SINGAPOREAN NOTICES TO MARINERS

**SECTION II
SINGAPORE NOTICES**

598/03 SINGAPORE STRAIT – Singapore – Pulau Damar Laut and Damar Laut Basin – Dredged depths

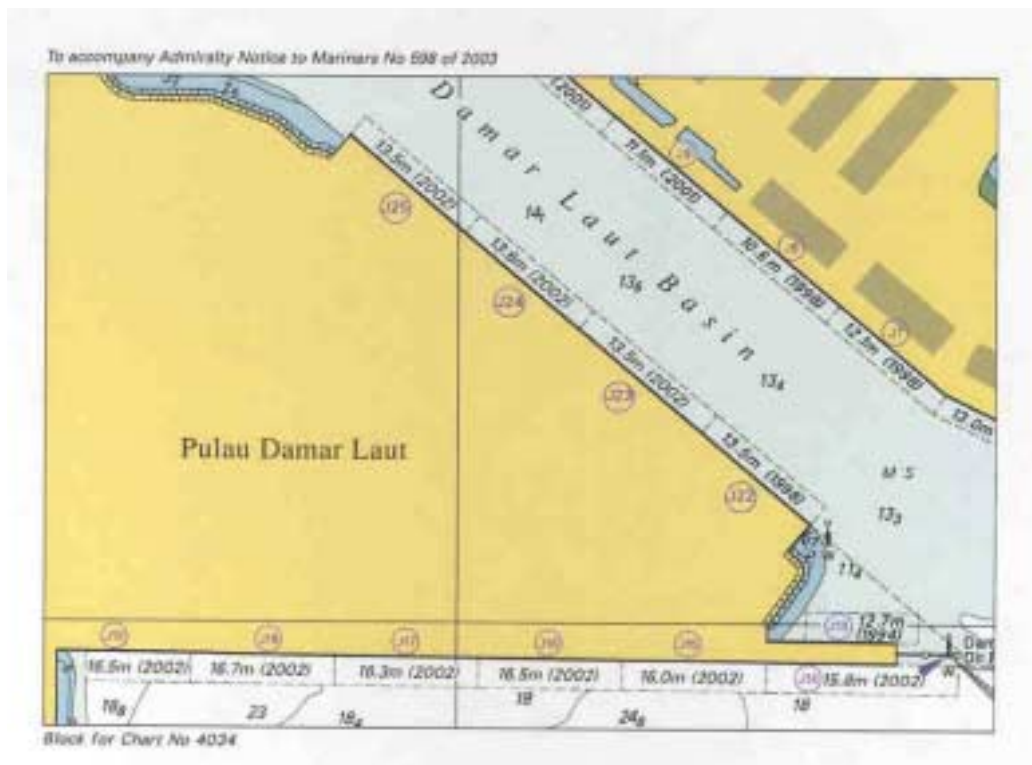
Insert The accompanying block, showing amendments to dredged depths, centred on: 1°18'.16N., 103° 43'.04E.

NOTE: This block correction is for illustration only. The actual block correction can be obtained from the Admiralty Notices to Mariners Weekly Edition 6, dated 6th February 2003 or from web site : http://www.ukho.gov.uk/wnm/2003/week06_596-745/chart4034nm598.pdf
